60 Parris Street - Final Traffic Comments

TO: Nell Donaldson, Planner
FROM: Lauren Swett, P.E. & Amy LeBel, E.I.T.
DATE: March 23, 2018
RE: 56-60 Parris Street Condominiums, Level III Preliminary

Final plans - Parris Terraces (2017-287)

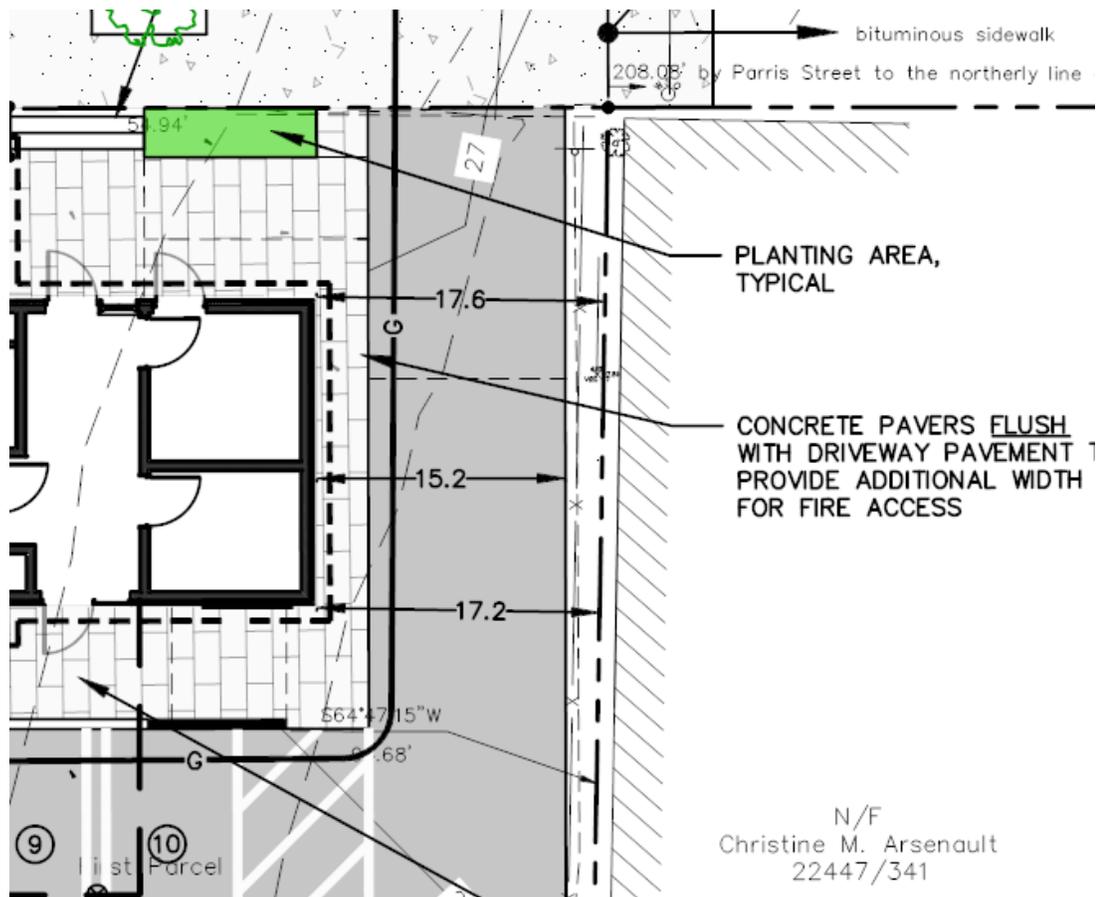
The final plans are showing a 12' driveway, not the 15+. As we discussed previously, is the sidewalk still going to be flush with the driveway and painted? And, if this is going to work, the planter on the uphill side will have to be reduced to the same width as the driveway and sidewalk to allow turning, or eliminated completely.

Take a look at the site plan (and make sure you're looking at the most recent version?). They show 15.2' with a change in surface material at the edge abutting the building:

I was looking at the newest set of plans in EPlan, which didn't show it this way, unless it wasn't the latest version. This works, thank you.
